ITEM E1 - ALASKAN WILDWOOD EAST

KPB 2021-126
S13 T04S R14W
Nikolaevsk

KPB File No.	2021-126
Plat Committee Meeting:	April 11, 2022
Applicant / Owner:	Joe Balyeat of Bozeman, MT
Surveyor:	Andre Kaeppele, Buk Saliz / Fixed Height LLC
General Location:	Nikolaevsk / Anchor Point APC

STAFF REPORT

PRELIMINARY PLAT

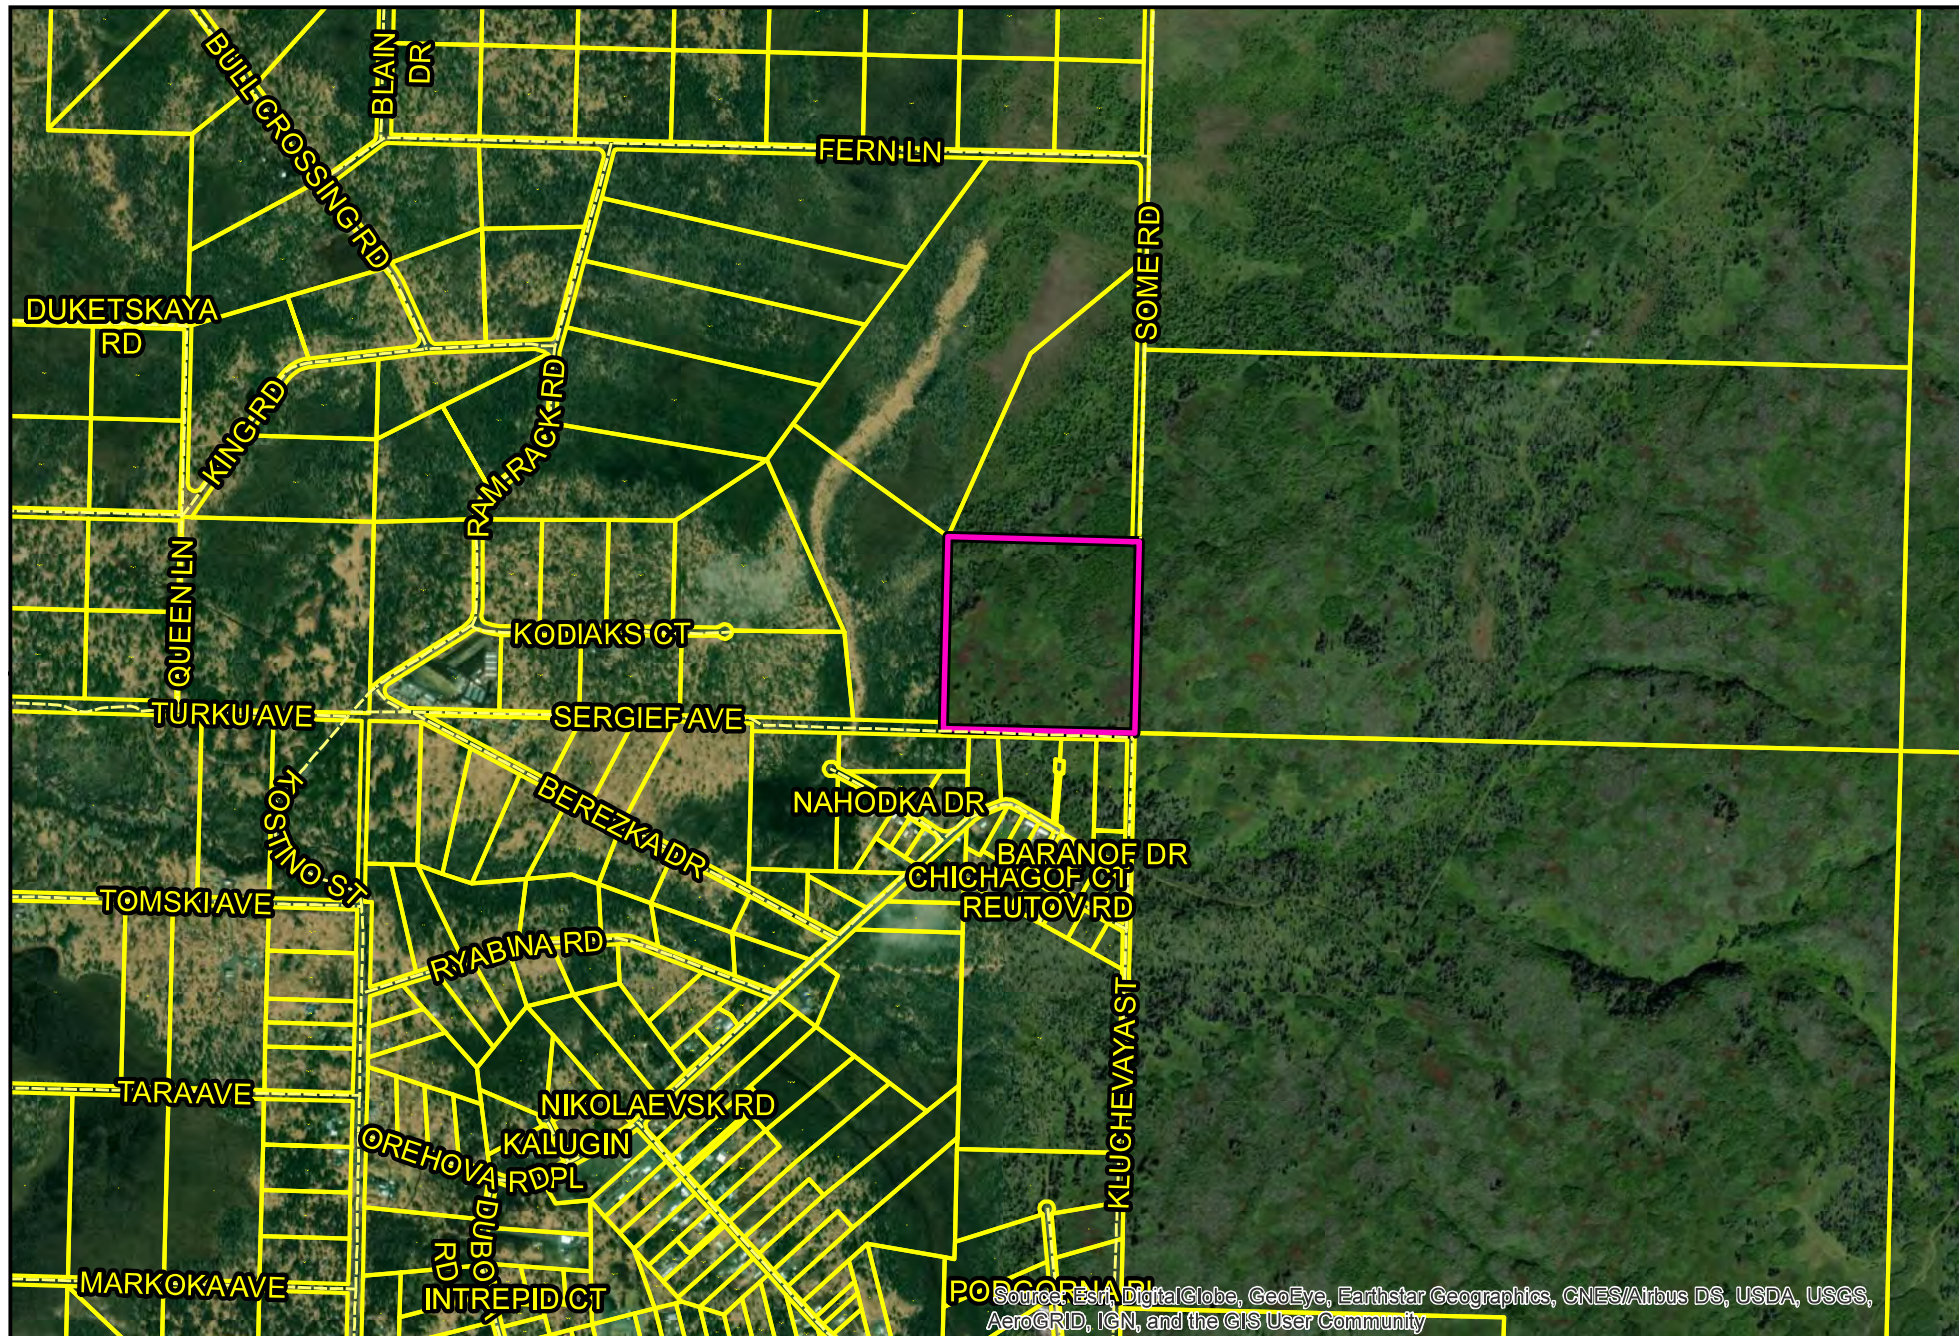
The original design, approved by the Plat Committee, was going to subdivide a 40 acre parcel into eight lots and provide a right of way dedication. This plat is being brought back to the plat committee as the surveyor has requested an exception to KPB 20.30.190 – lots dimensions, 3:1 depth to width ratio for Lot 4.

KPB 20.30.190 – Lots dimensions (3:1 depth to width ratio for Lot 4)

Staff Discussion: The Kenai Peninsula Borough Plat Committee heard and approved the preliminary plat at the September 27, 2021 meeting. A final was received for review on November 8, 2021 with the same design. Due to the terrain, centerline profiles were requested to determine if slope easements would be required. The surveyor determined, due to the terrain, the road needed to be slightly adjusted. The final submitted on February 22, 2022 showed a minor design change. There are still eight lots but the configuration and the road design have slightly changed. The design is keeping the lots above 200,000 square feet so that soils analysis report is not required. The new design has resulted in one of the lots not complying with the 3:1 depth to width requirements.

5. KPB Code requires a ratio of 3:1 for the depth to width of lots.
6. Due to the change in design, the ratio for Lot 4 is 3.3:1.
7. There are some low wet lands present in the western portion of Lot 4.
8. The change in design can be attributed to the terrain and the need to place the right of way dedication in the best location.
9. The road has been shifted to the east to provide a better connection to Sergief Avenue.
10. Slope easements are proposed and have been reviewed and approved by the KPB Roads Department.
11. The redesign changed from four lots on each side of the dedication to five on one side and three on the other.

Approval will require a new plat note for the exception granted in addition to any corrections noted by staff during their final review.

Staff recommendation: place notes on the final plat indicating any exceptions granted by the Plat Committee with the meeting date and provide the correct Wastewater Disposal note.

PLAN VIEW

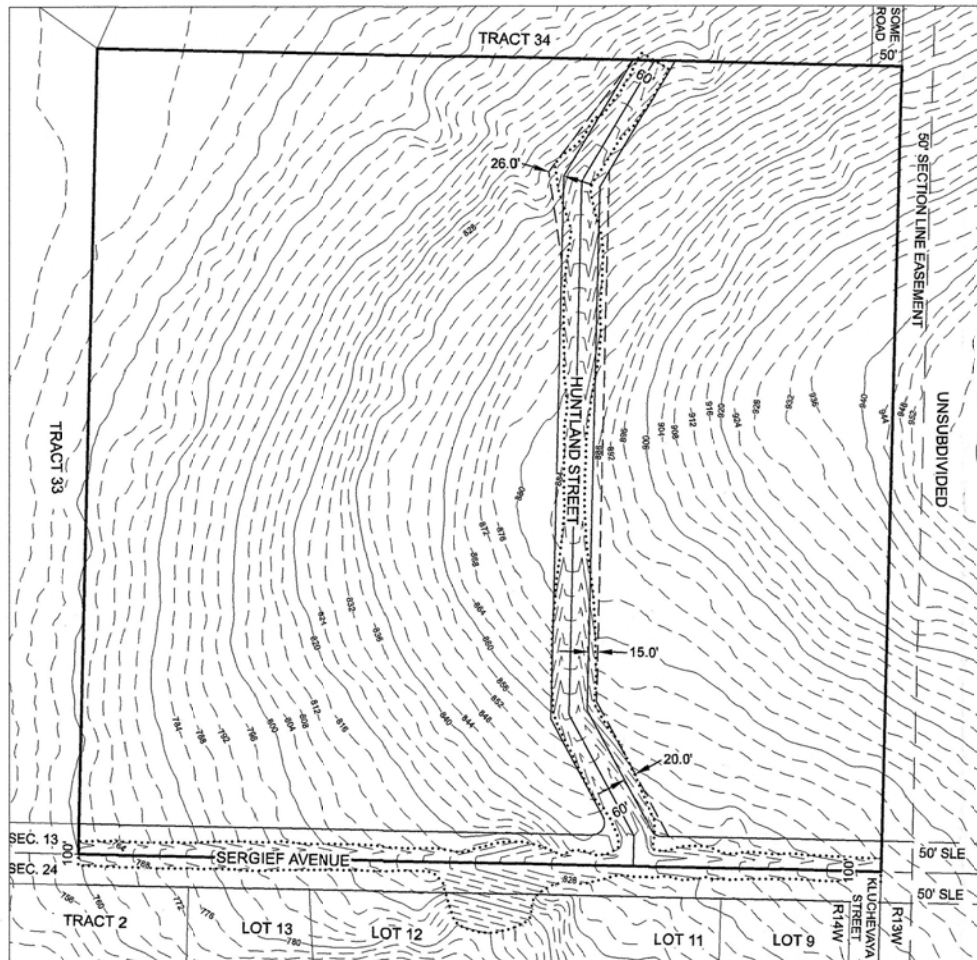
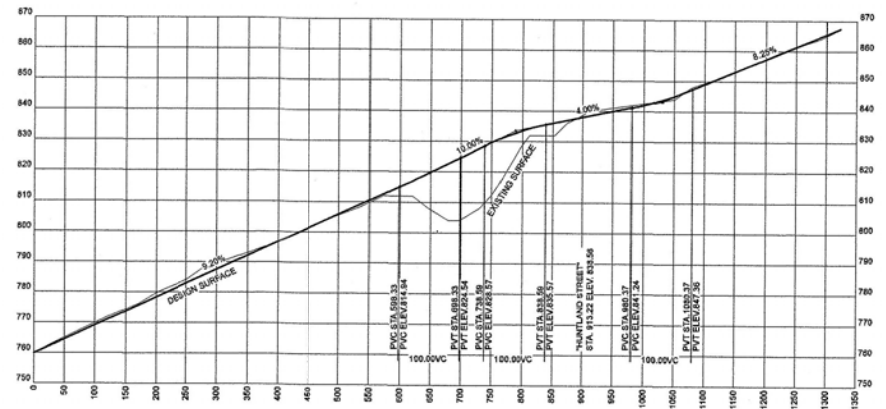
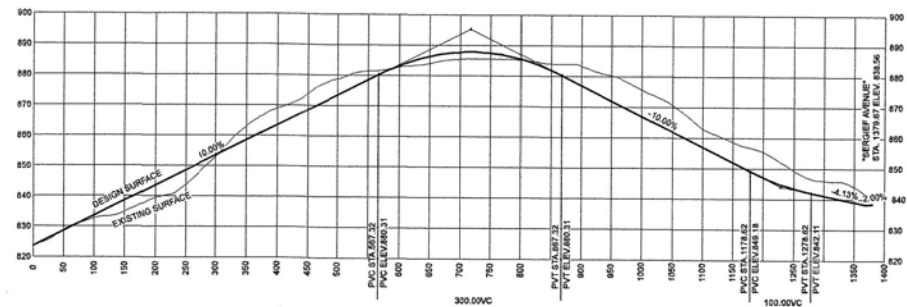
Staff recommendation: *If necessary, provide lateral support (slope) easements for any roadways that are affected by steep terrain so that a road way can be constructed with no more than a 10% grade. Provide road plans with centerline profiles and cross sections to show the roadway limits.*

Staff recommendation: *Provide road plans with centerline profiles and cross sections to show the roadway limits.*

KPB 20.30.190 – Lots Dimensions

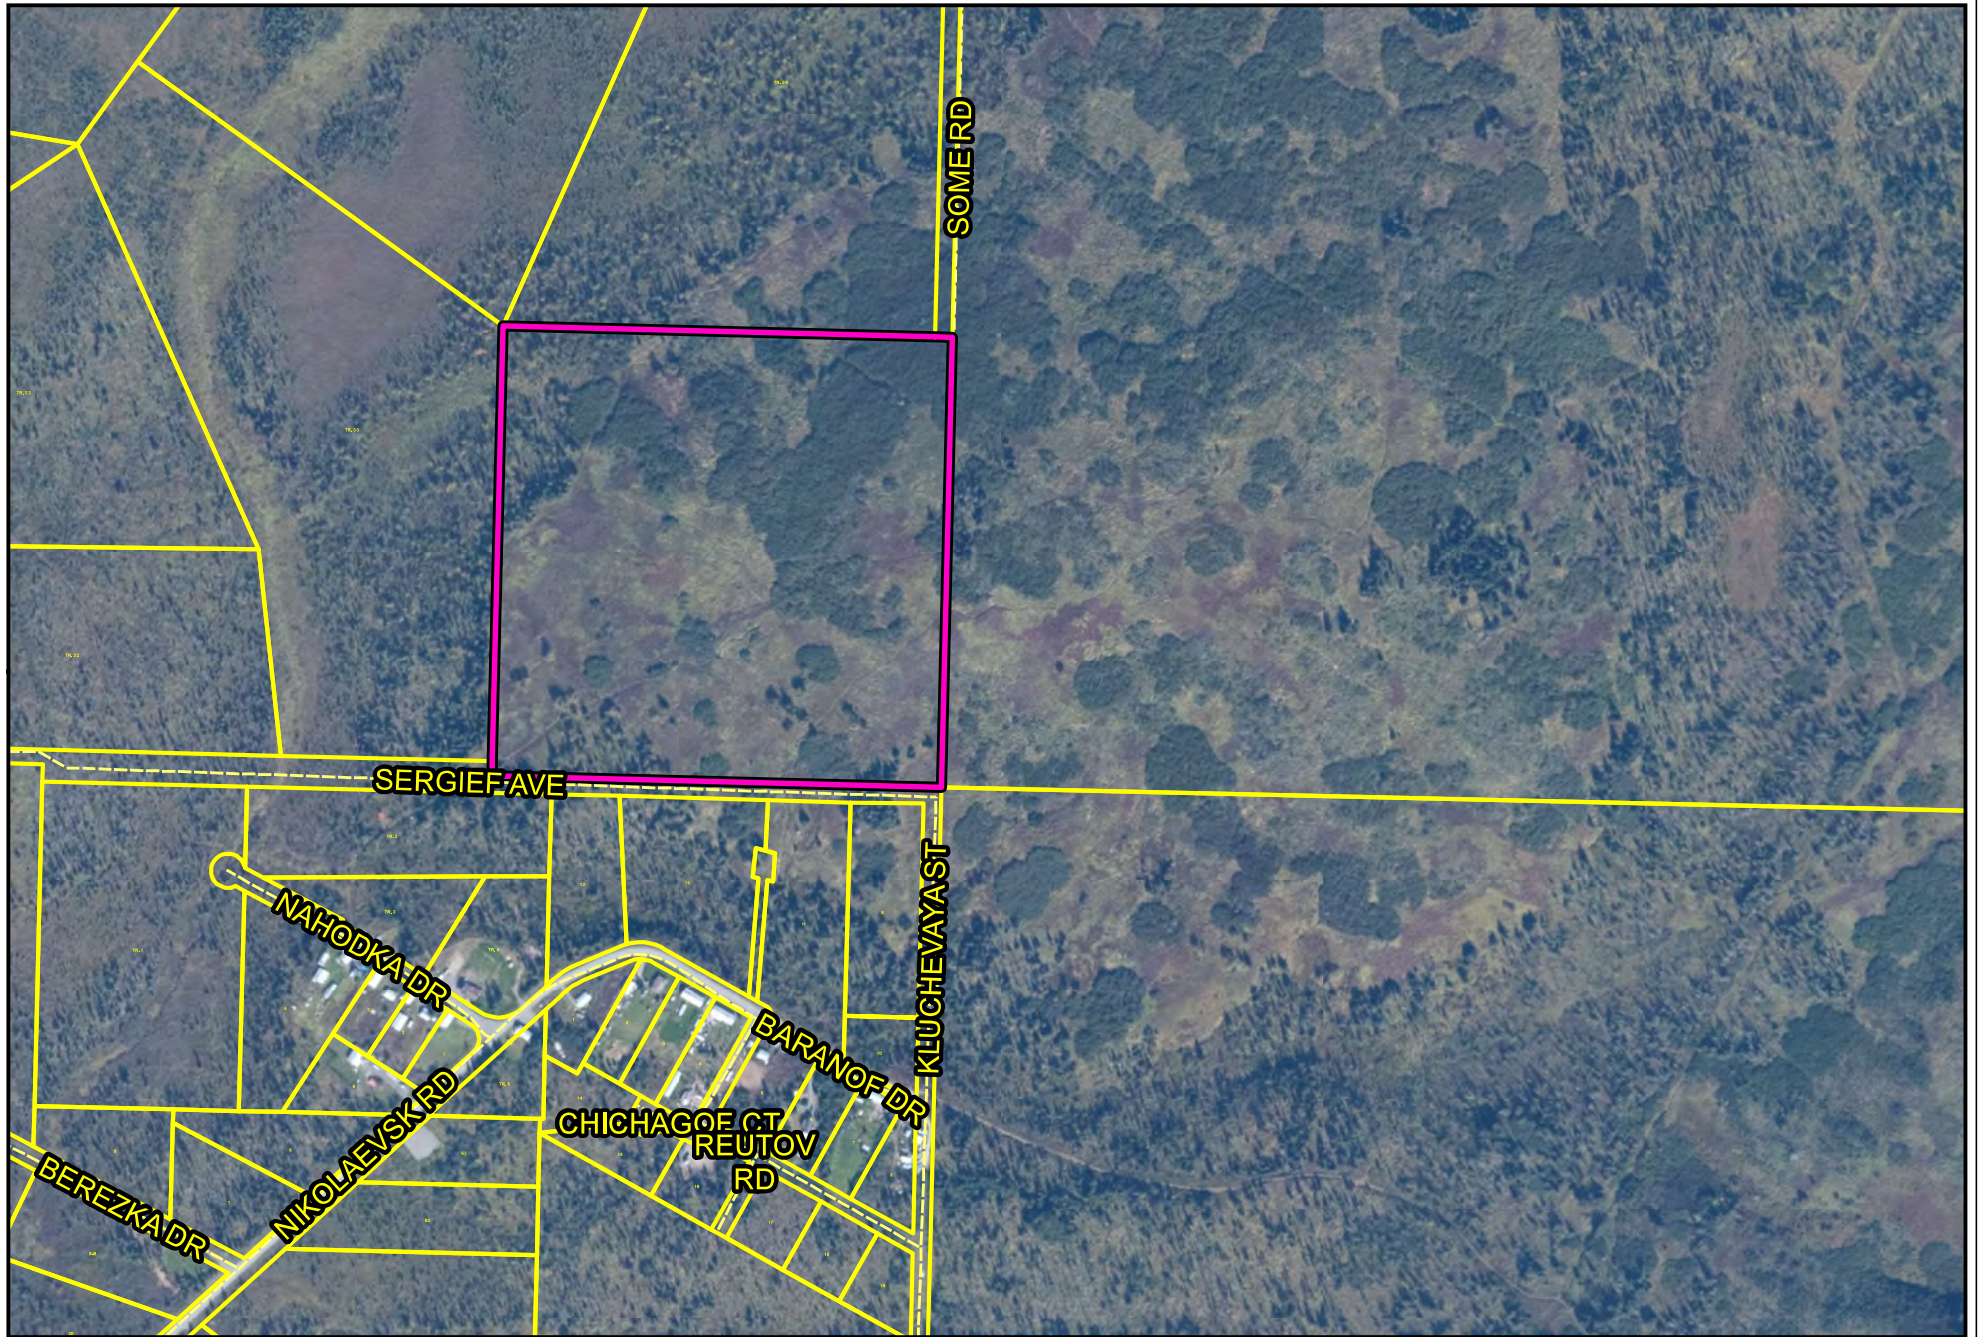
- Update the subdivision name to Alaskan Wildwood Subdivision. Phase is a designation used for a portion of a larger approved plan where portions are finalized at different times.

- Provide the KPB file number (2021-126) near or within the title block.
 - Within the title block remove the reference to Document No. 2019-002734 as that is a deed and not a document that created the parcel of land.

- Provide the owners name and mailing address within the title block.
 - Update the sheet to 1 of 1.
- C. The location, width, and name of existing or platted streets and public ways, railroad rights-of-way, and other important features such as section lines or political subdivisions or municipal corporation boundaries abutting the subdivision;

- Staff recommendation:** Label all section line easements within and abutting the subdivision such as the one within Section 19. Provide a street name label and right of way width for Kluchevaya Street.

Staff recommendation: *The hatching used on the plat is typically used to depict vacations. No hatching is required for ROW dedications. Provide labels that state ROW being dedicated this plat. Update to the subdivision boundary to show the parent parcel as the boundary.*

Staff recommendation: *Per KPB GIS data, the northwest corner may contain wetlands. Verify during the field survey and depict and label any low wet areas that affect the subdivision.*

Staff recommendation: *Provide a minimum 30 foot dedication along the eastern boundary for the extension of Some Road.*

Staff recommendation: *Within the drawing, depict and label the 20 foot building setback.*

Plat note 1 is duplicated within plat note 3. Remove plat note 1 or remove that portion from plat note 3.

Plat note 6 refers to a registered trademark. Staff is unsure as to the intent for this note, as there does not appear to be any reference outside of the plat note to Alaska Wildwood Ranch. Remove plat note 6 from the final plat.
